From: So Kim
Sent time: 02/20/2019 10:07:23 AM
To: Selim <Selim@sawayaeng.com>
Cc: Ara Mihranian; Jill Martin <jmartin@trumpnational.com>; Rehm, Zach@Coastal <Zach.Rehm@coastal.ca.gov>
Subject: RE: Tract 50666 Fencing plan

Hi Selim,
Attached are corrections to the fencing plan. Please feel free to contact me with any questions. I'm copying Zach on this email for his input on this version.

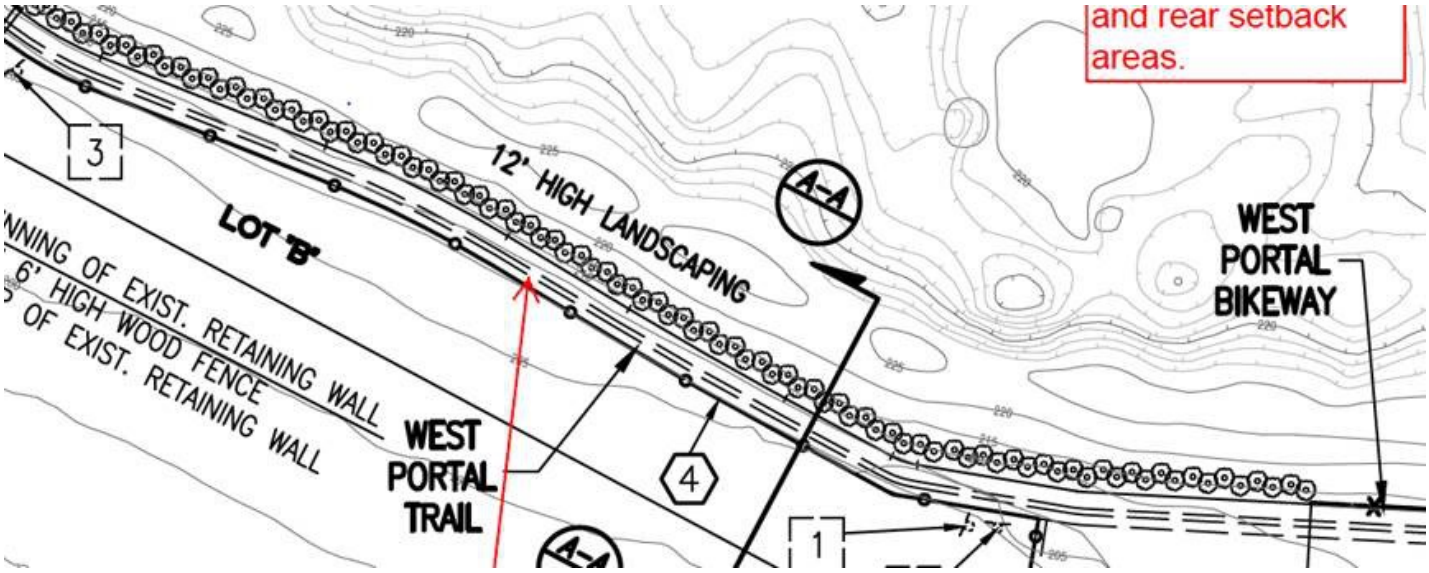
2) Change the notation "12' HIGH LANDSCAPING" to "LANDSCAPING NOT TO EXCEED 12' IN HEIGHT OR THE RIDGE ELEVATION OF THE SOUTHERLY BERM". Based on your map, it appears that the ridge elevation of southerly berm would be 225.

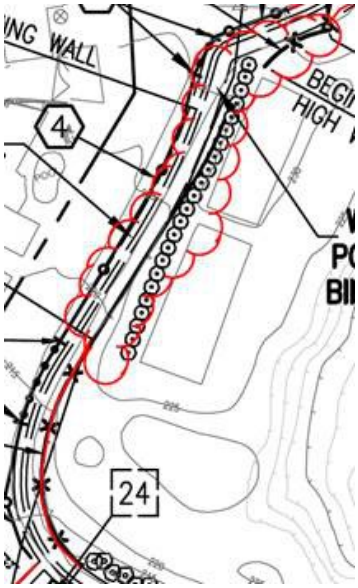
3) Based on Mitigation Measure H-1 above, remove the 6' tall fence located in the bubbled area since there is already a hedge there and begin the fence from the south end of the west hedge to the west end of the south hedge as shown in the solid red line below. Please change the notation from "6' HIGH LATTICE" to "LATTICE FENCE NOT TO EXCEED 6' IN HEIGHT OR THE RIDGE ELEVATION OF THE SOUTHERLY BERM". I understand that by doing so, there may be a gap between the west hedge and the new fence.
